RE: **1-ZN-2023 and 1-GP-2023**
6C692 (Key Code) and 98T77 (Keycode)
Pinnacle Peak Doggy Daycare

Planning & Development Services has completed review of the above referenced development application. The following comments represent issues or deficiencies identified by the review team and are intended to provide you with guidance for compliance with city codes, policies, and guidelines.

PRELIMINARY Basis of Design Report	
<input type="checkbox"/> ACCEPTED	
<input type="checkbox"/> ACCEPTED AS NOTED	
<input checked="" type="checkbox"/> REVISE AND RESUBMIT	
<small>Disclaimer: If accepted, the preliminary approval is granted under the condition that a final basis of design report will also be submitted for city review and approval (typically during the DR or PP case). The final report shall incorporate further water or sewer design and analysis requirements as defined in the city design standards and policy manual and address those items noted in the preliminary review comments (both separate and included herein). The final report shall be submitted and approved prior to the plan review submission. For questions or clarifications contact the Water Resources Planning and Engineering D

PREPARED FOR
ATLANTIC DEVELOPMENT & INVESTMENTS, INC.

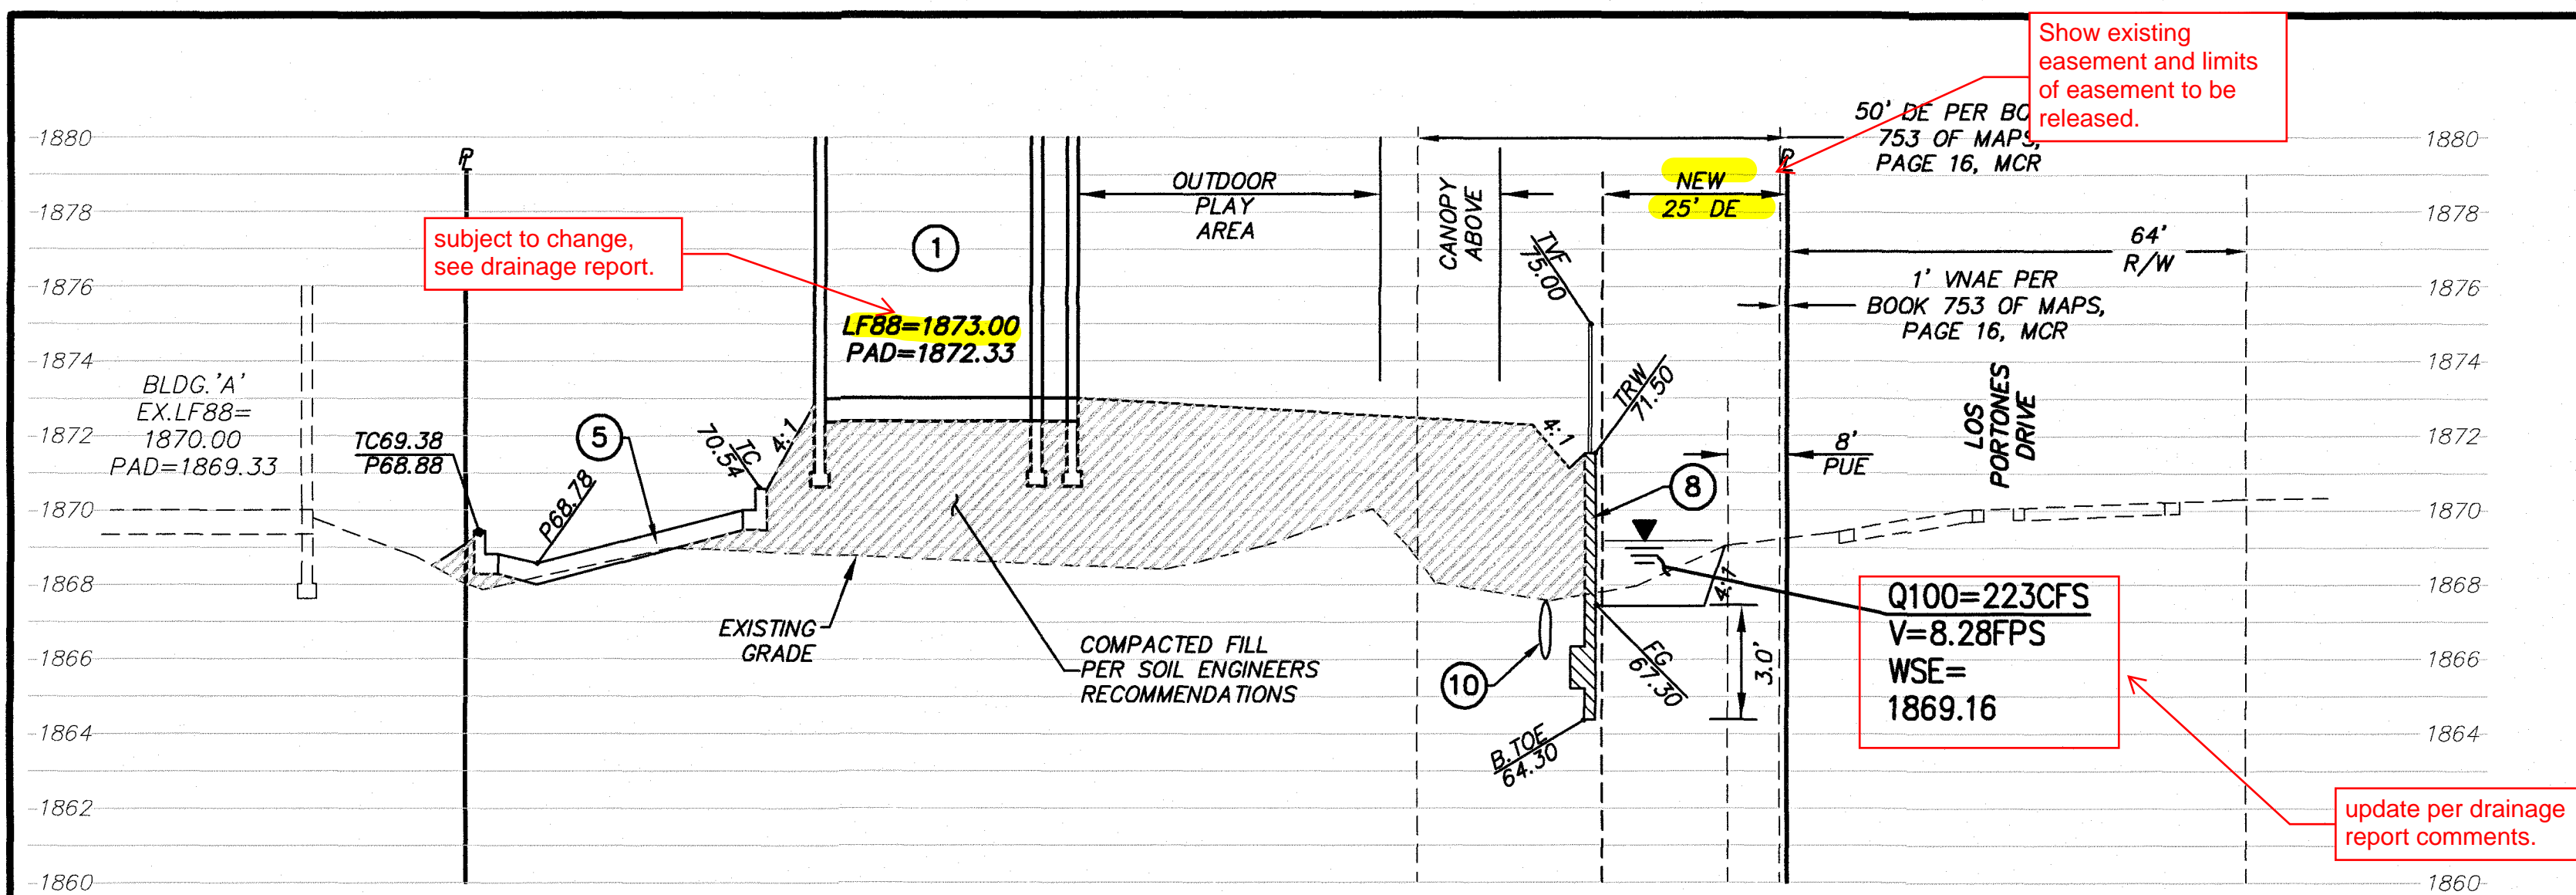
Add:
LFF =
BFE FEMA =
BFE Existing Conditions =
RFE =
